- 4. Forest Hills Lookout Subdivision Watson Addition No. 2
KPB File 2024-101
Johnson Surveying / Eicher
Location: Diamond Willow Lane
Sterling Area**

**ITEM 4 - PRELIMINARY PLAT
Forest Hills Lookout Subdivision Watson Addition No. 2**

KPB File No.	2024-101
Plat Committee Meeting:	October 14, 2024
Applicant / Owner:	Ruby Ann and Jacob Eicher of Soldotna, AK
Surveyor:	Jerry Johnson – Johnson Surveying
General Location:	Diamond Willow Lane, Sterling Area

Forest Hills Lookout Watson Addition No. 2 Preliminary Plat

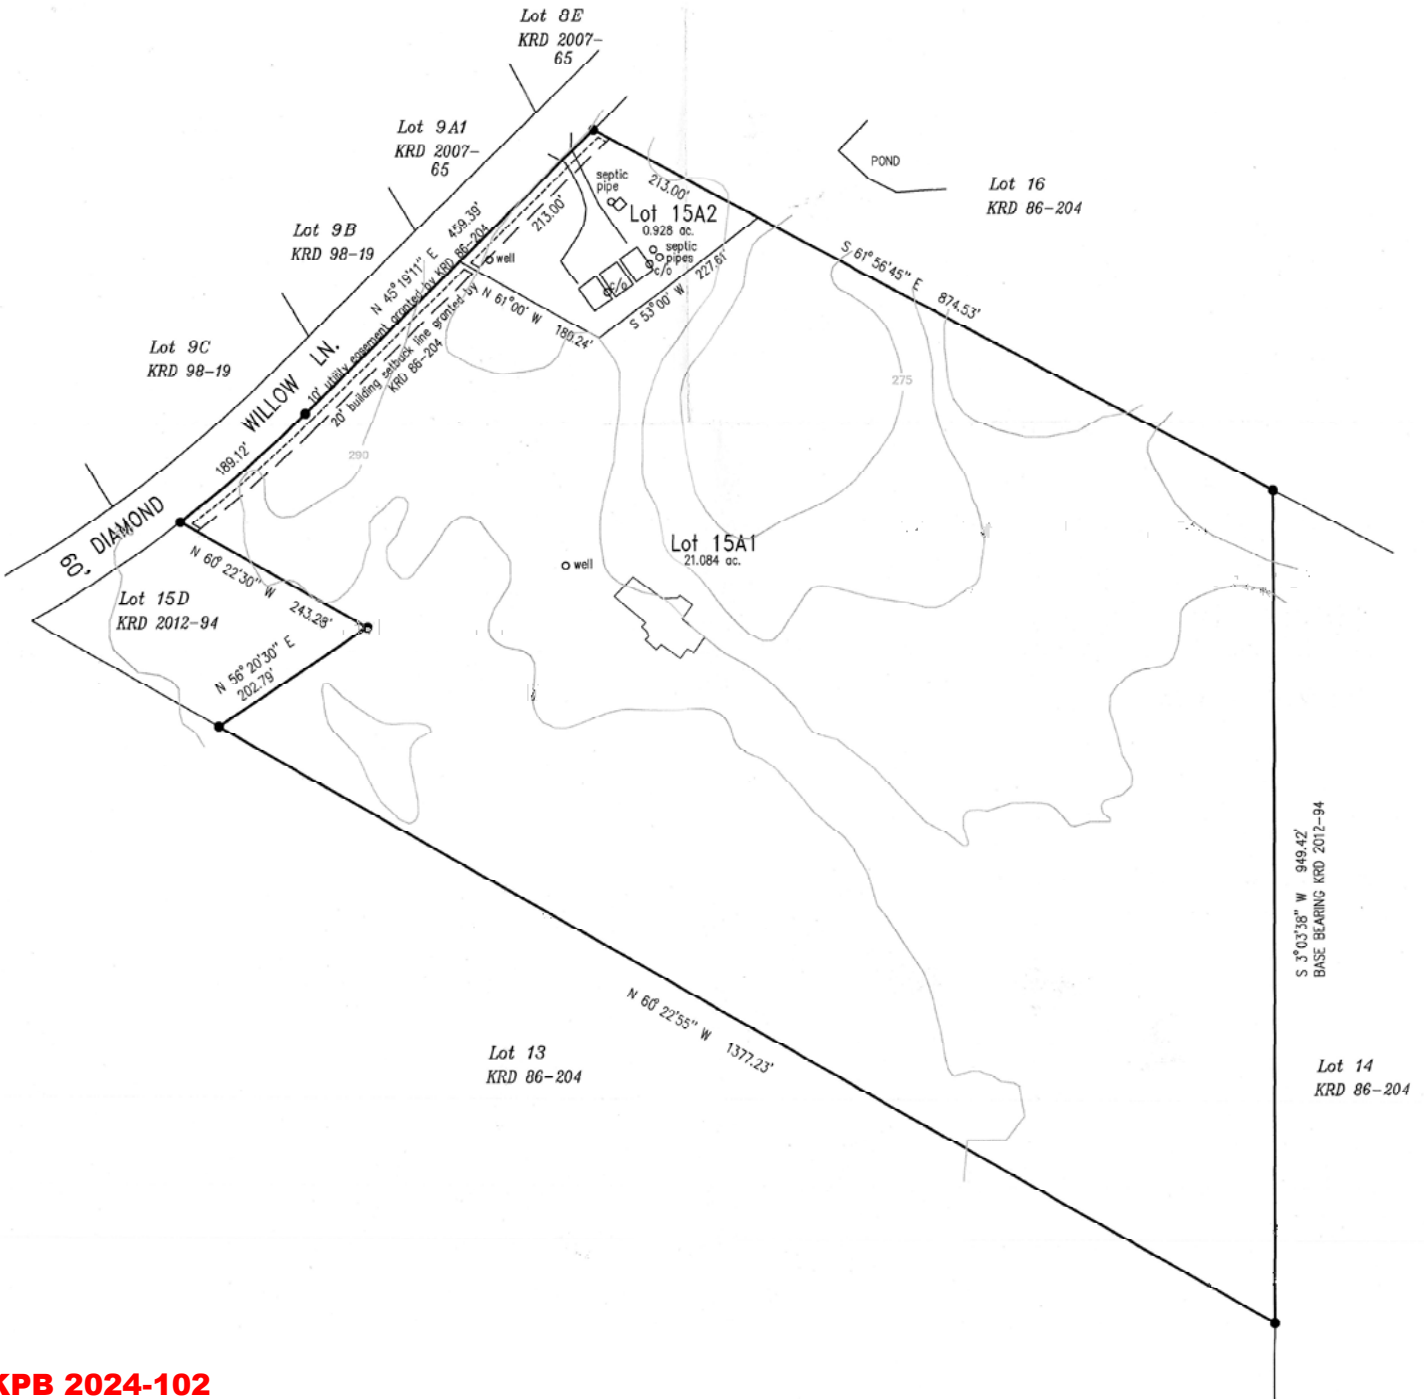
Block length is not compliant, but the block this lot is located in is chopped up in an irregular shape and with large irregular lots. **Staff recommends** the Plat Committee concur an exception is not needed at this time but request a plat note be added that further division of Lot 15A1 will require a road dedication.

Multiple structures are depicted on the plat. When the plat is complete there will be three structures located on Lot 15A2 and one structure on Lot 15A1. A well is depicted on Lot 15A2 that appears to be within the 20-foot building setback.

A well is depicted on Lot 15A2 that appears to be within the 20-foot building setback. **Staff requests** a note be placed on the final plat to indicate that acceptance of the plat by the Borough does not indicate acceptance of any encroachments.

Update the Plat Approval date to October 14, 2024.
Moify KPB File Number to 2024-101

Correct lot number to "Lot 15A Forest Hills Lookout Watson Addition"

Correct lot label directly east adjacent to the subdivision, to: Lot 15B KN 2012-94

Correctly represent the lots across Diamond Willow Ln
